**Comments of the Sierra Club, et al.,
to the Department of State on the
Supplemental Draft Environmental Impact Statement for the
TransCanada Keystone XL Pipeline**

Submitted June 6, 2011

Figure 4.

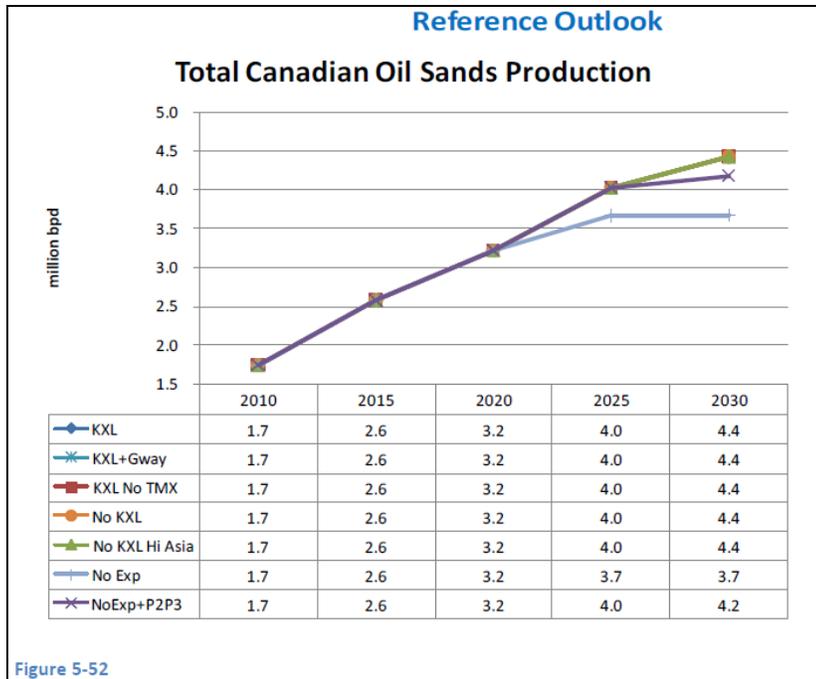
The graphs on page 8 of the EnSys Report illustrate this projected under different demand scenarios. (Reproduced as figures 4 and 5 below.). Figure 4 (showing the Reference Outlook) and Figure 5 (showing the Low Demand Outlook), both shown below, show a stark difference in production levels if Keystone XL were built versus if it were not built. Together, the graphs show that Keystone XL is expected to increase tar sands production by 750,000 to 900,000 bpd.

Under the Reference Outlook, tar sands production will increase to roughly 3.25 million bpd by 2020 whether or not Keystone XL is built. If Keystone XL is built, production will continue to increase to just under 4.5 mbd by the year 2030. However, if Keystone XL is not built (and no other pipelines are built), production will increase at a slower pace between 2020 and 2024 and then level out at around 3.6 mbd by the year 2024. Thus, under the Reference Outlook, Keystone XL will cause a production increase of roughly 900,000 bpd more than under the status quo.

Figure 5.

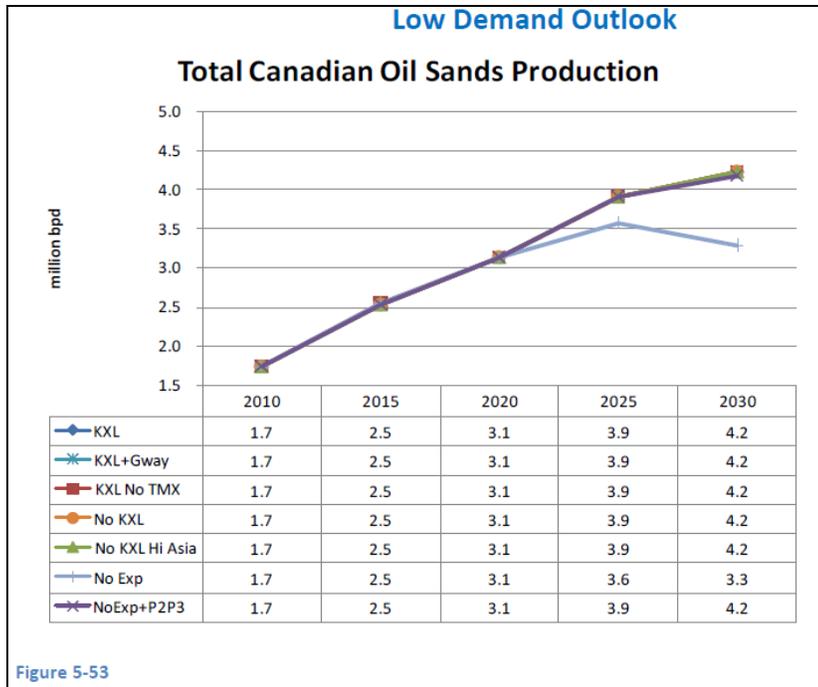
The Low Demand Outlook also shows a significant difference in tar sands production levels between the Keystone XL scenario versus the “No Exp” scenario. Under both scenarios, production will increase to just over 3 million bpd by 2020 regardless of whether Keystone XL is built. If Keystone XL is built, production will then increase until reaching roughly 4.25 million bpd by 2030. Under the No Expansion scenario, however, production will increase at a shallower rate, peak in 2025 at about 3.5 million bpd, and then decrease to roughly 3.25 million bpd by 2030. Thus, under both the Reference Outlook and the Low Demand Outlook, Keystone XL will cause around a nearly million bpd increase in tar sands production levels higher than what would occur under the status quo.

Thus, the EnSys Report clearly shows that Keystone XL will have a discernable impact on tar sands production rates. Indeed, this impact is much more than “a reasonably close causal relationship” between KXL and increased tar sands production. *Public Citizen*, 541 U.S. at 767. This requires an analysis of the trans-boundary impacts associated with increased tar sands production. *Id.*

Figure 16. Average annual world oil prices in three cases, 1980-2035 (2008 dollars per barrel)

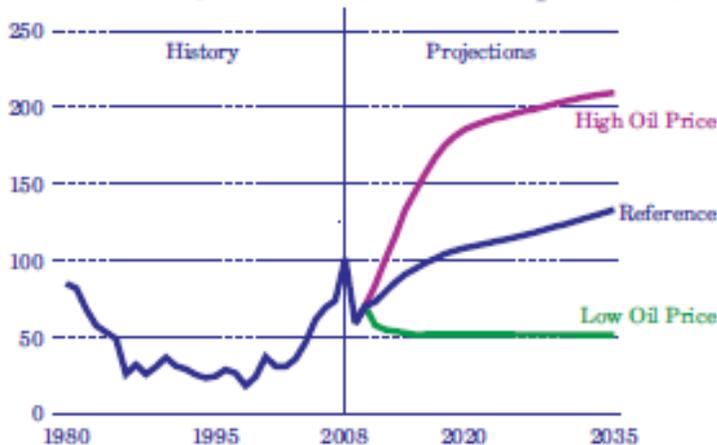
Second, the EnSys 2010 analysis does not really take a hard look at different possible crude price scenarios. It cites to EIA Annual Energy Outlook 2010 Reference Case as the basis for assuming that crude will cost \$111.49 per barrel in 2030 under the AEO outlook scenario, and \$107.00 per barrel under the low demand scenario. EnSys 2010 at 39. However, the EIA analysis actually reflects a very wide range of possible oil prices, as shown in this chart (EIA Annual Energy Outlook 2010 at 28):

As the chart indicates, 2030 oil prices could range as low as \$50 and as high as \$200; the reference case is merely a number in between. Either the low end or the high end of the projections could have a profound impact on crude oil demand, and hence refining. And the high prices in particular cannot be construed as merely driving higher refining profit margins, and hence more refining. Prices at these levels would surely increase as well the demand for previously non-competitive clean energy alternatives. The analysis of an energy future with and without KXL is not complete without a realistic assessment of differing price scenarios, and their potential impact on the availability of clean energy alternatives.
